**CAMECO RESOURCES
CROW BUTTE OPERATION**

February 1, 2011

Re: Annual Report of Changes, Tests, or Experiments
License No. SUA-1534
Docket No. 40-8943

2010 SERP Evaluation Index

Figure 5.1-1: Crow Butte Resources Organizational Chart

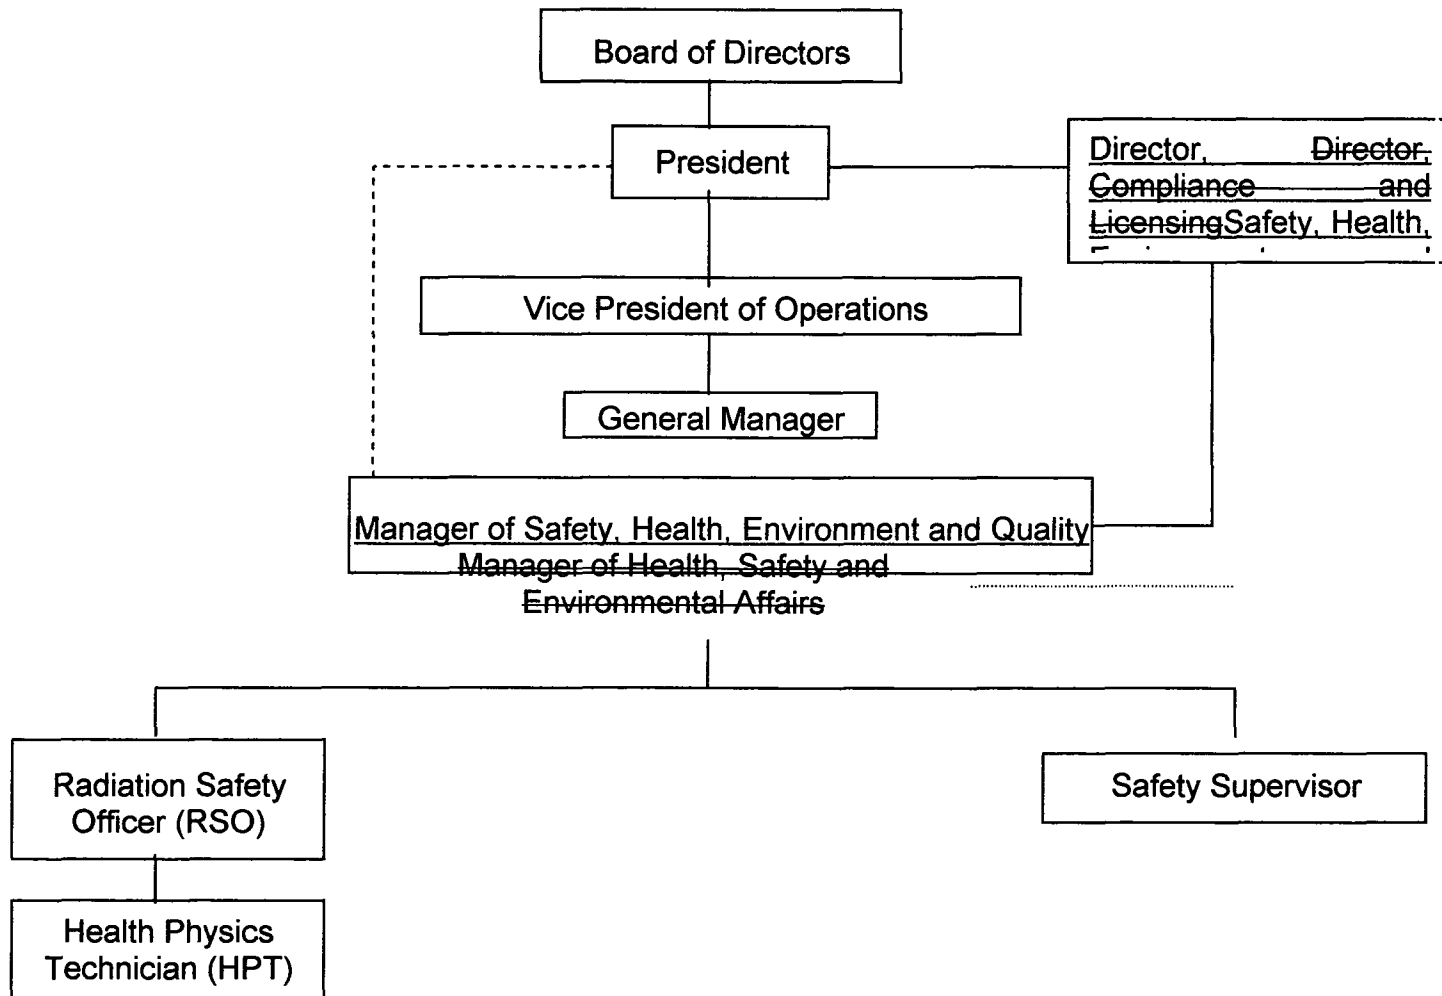
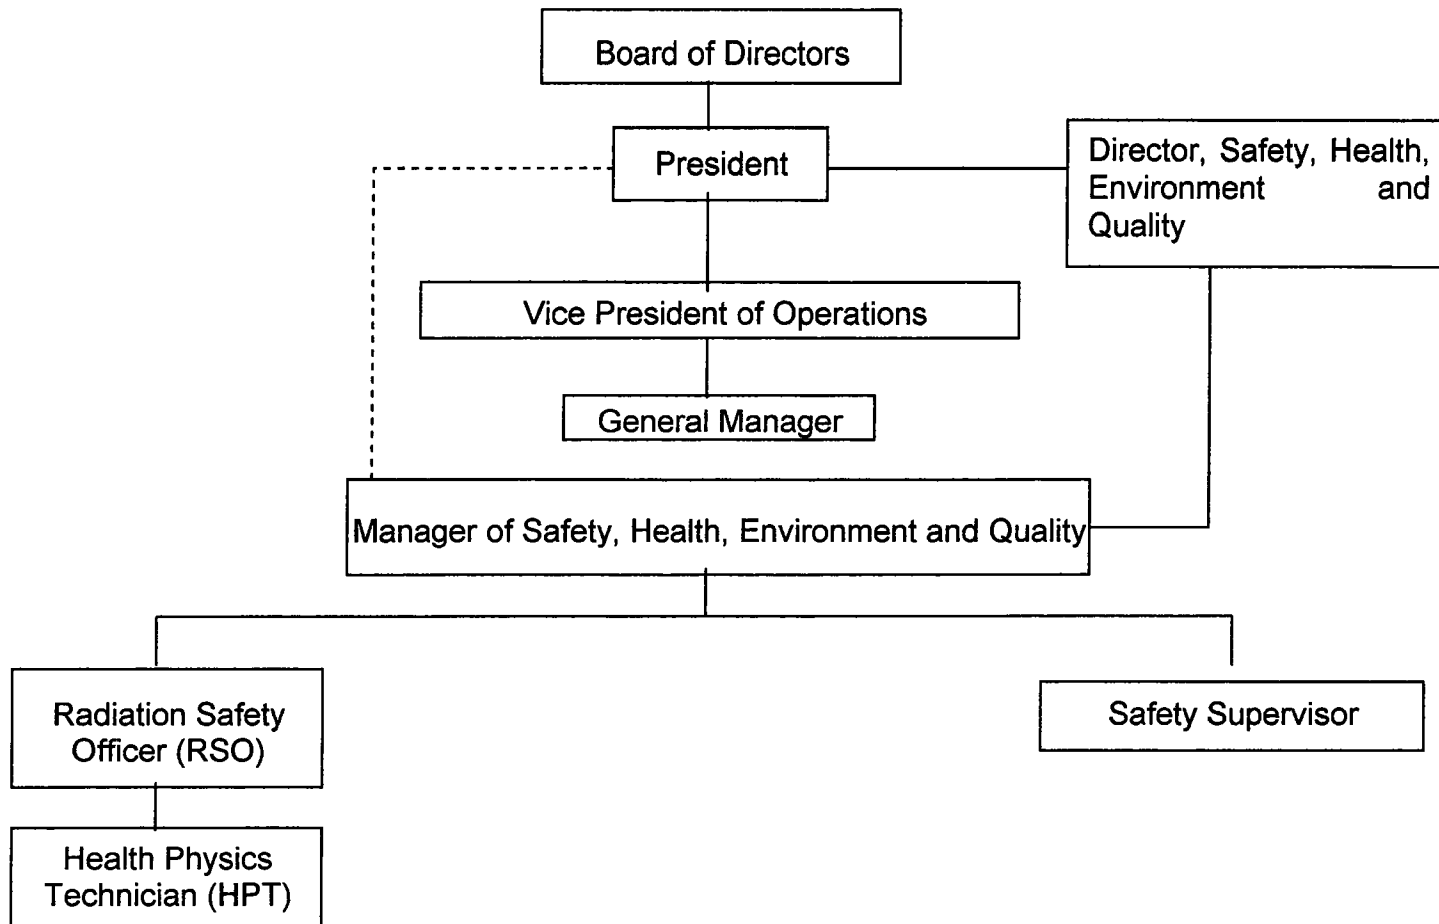
The purpose of the SERP evaluation was to review a change made to the corporate organizational structure. Specifically, to remove the position of Director, Compliance and Licensing, and add the position of Director, Safety, Health, Environment and Quality and to re-name the Manager of Safety, Health and Environmental Affairs position to Manager of Safety, Health, Environment and Quality.

An organizational change has been made that indirectly affects the reporting responsibilities of the radiation safety staff. The reporting for the Manager of Safety, Health, Environment and Quality has been changed as shown in the revised Figure 5.1-1 from the approved application. The SHEQ Manager now reports directly to the Director, Safety, Health, Environment and Quality who reports directly to the President. The new position of Director, Safety, Health, Environment and Quality has been added to the organizational structure. This position reports directly to the President and is responsible for ensuring the corporate personnel comply with industrial safety, radiation safety and environmental protection programs as stated in the EHS Management System. Since the RSO reports to the Manager of Safety, Health, Environment and Quality who in turn reports to the Director, Safety, Health, Environment and Quality, a change in the reporting for the Manager of Safety, Health, Environment and Quality and the removal of the Director, Compliance and Licensing position, will indirectly affect the radiation safety staff reporting.

The RSO is responsible for the development, administration, and enforcement of all radiation safety programs. The RSO is authorized to conduct inspections and to immediately order any change necessary to preclude or eliminate radiation safety hazards and/or maintain regulatory compliance. The RSO is responsible for the implementation of all on-site environmental programs, including emergency procedures. The RSO inspects facilities to verify compliance with all applicable requirements in the areas of radiological health and safety. The RSO works closely with all supervisory personnel to insure that established programs are maintained. The RSO is also responsible for the collection and interpretation of employee exposure related monitoring, including data from radiological safety. The RSO makes recommendations to improve any and all radiological safety related controls. The RSO has no production-related responsibilities. The RSO will report to the Manager of Safety, Health, Environment and Quality.

Figure 5.1-1: Crow Butte Resources Organizational Chart

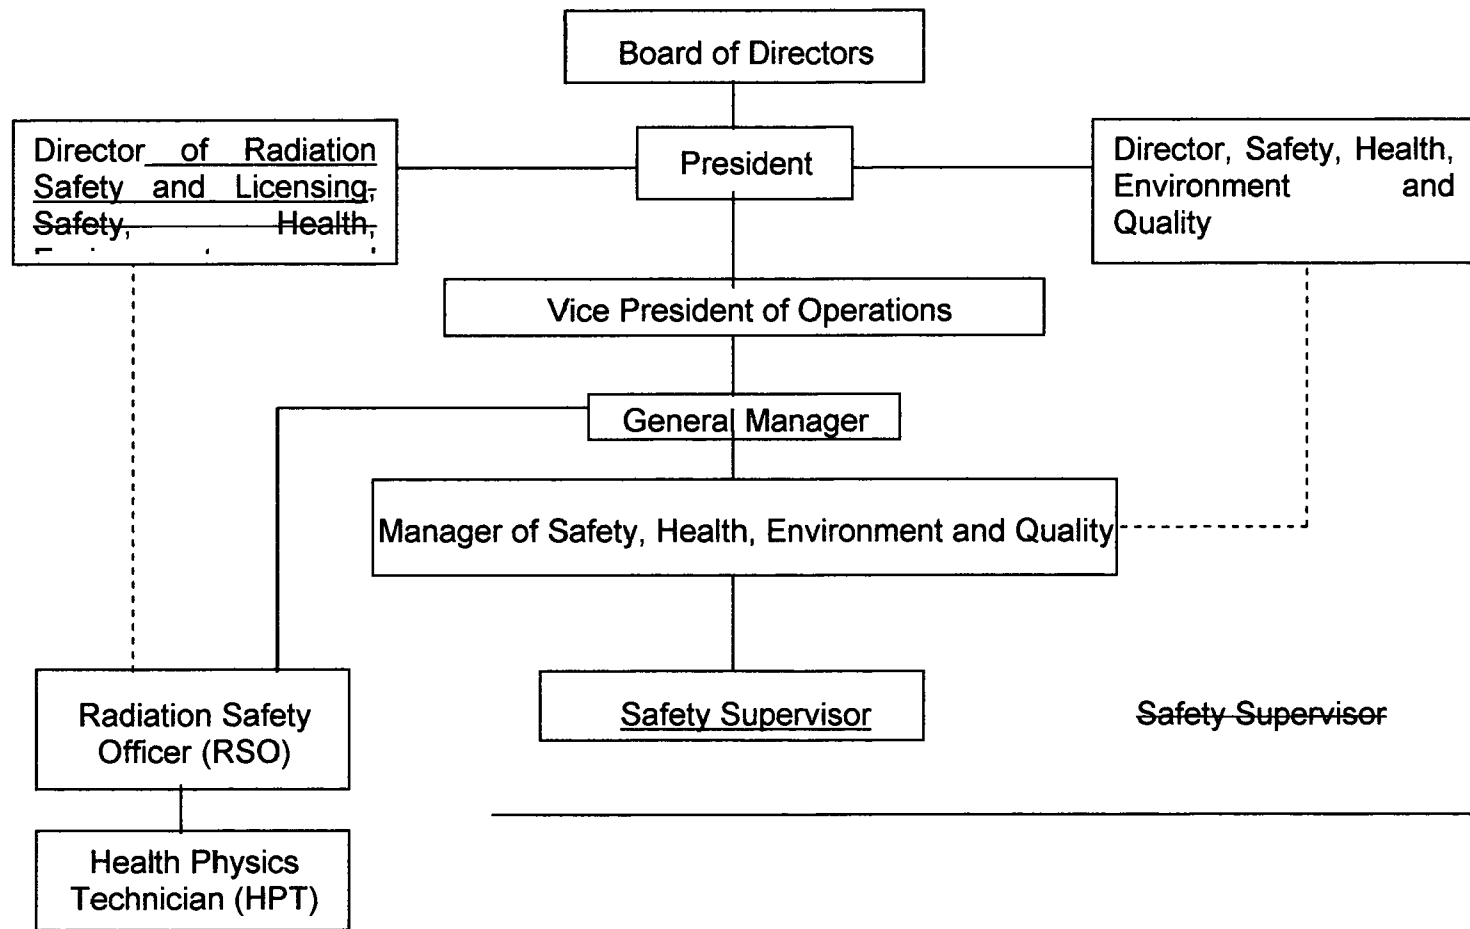
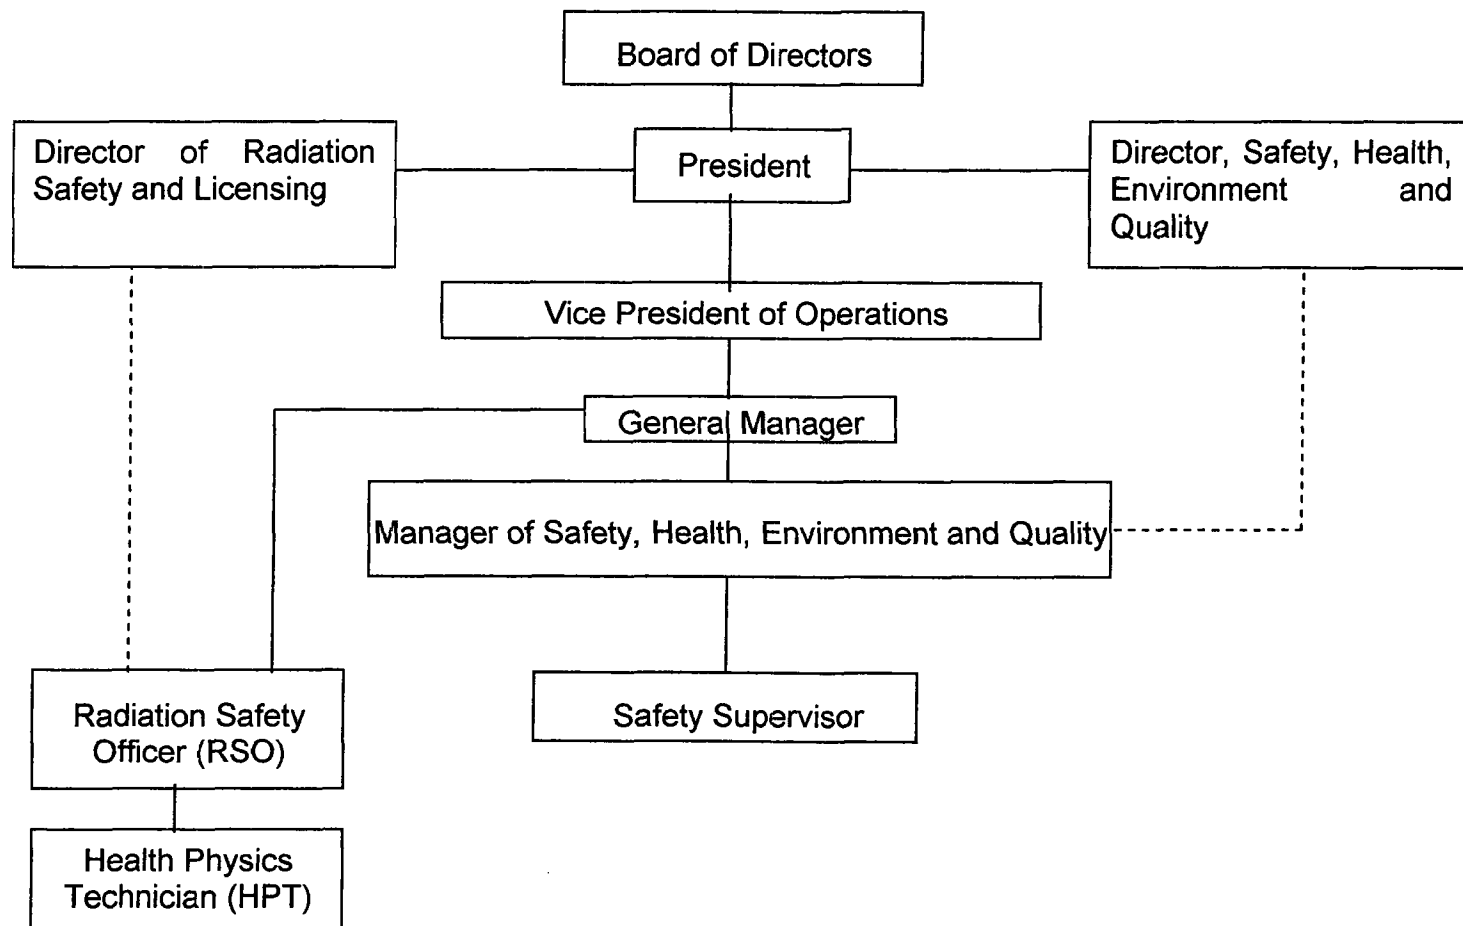
The purpose of the SERP evaluation was to review a change made to the corporate organizational structure. The evaluation adds the position of Director of Radiation Safety and Licensing and changes the reporting requirements for the Safety, Health, Environment, and Quality Manager and the Radiation Safety Officer.

An organizational change has been made that directly affects the reporting responsibilities of the radiation safety staff. The reporting for the Manager of Safety, Health, Environment and Quality (SHEQ) and Radiation Safety Officer (RSO) has been changed as shown in the revised Figure 5.1-1 from the approved application. The SHEQ Manager and RSO now report directly to the General Manager who reports directly to the Vice President. The new position of Director of Radiation Safety and Licensing has been added to the organizational structure. This position reports directly to the President and is responsible for submitting permit and license applications to appropriate regulatory agencies and will manage the approval process. This position will also act as a resource for the site SHEQ managers to ensure that permit conditions, agency responses, revisions, and, other Cameco SHEQ requirements are met. Since the RSO reports directly to the General Manager who in turn reports to the Vice President a change in the reporting for the RSO will directly affect the radiation safety staff reporting.

The RSO is responsible for the development, administration, and enforcement of all radiation safety programs. The RSO is authorized to conduct inspections and to immediately order any change necessary to preclude or eliminate radiation safety hazards and/or maintain regulatory compliance. The RSO is responsible for the implementation of all on-site environmental programs, including emergency procedures. The RSO inspects facilities to verify compliance with all applicable requirements in the areas of radiological health and safety. The RSO works closely with all supervisory personnel to insure that established programs are maintained. The RSO is also responsible for the collection and interpretation of employee exposure related monitoring, including data from radiological safety. The RSO makes recommendations to improve any and all radiological safety related controls. The RSO has no production-related responsibilities. The RSO will report to the General Manager.
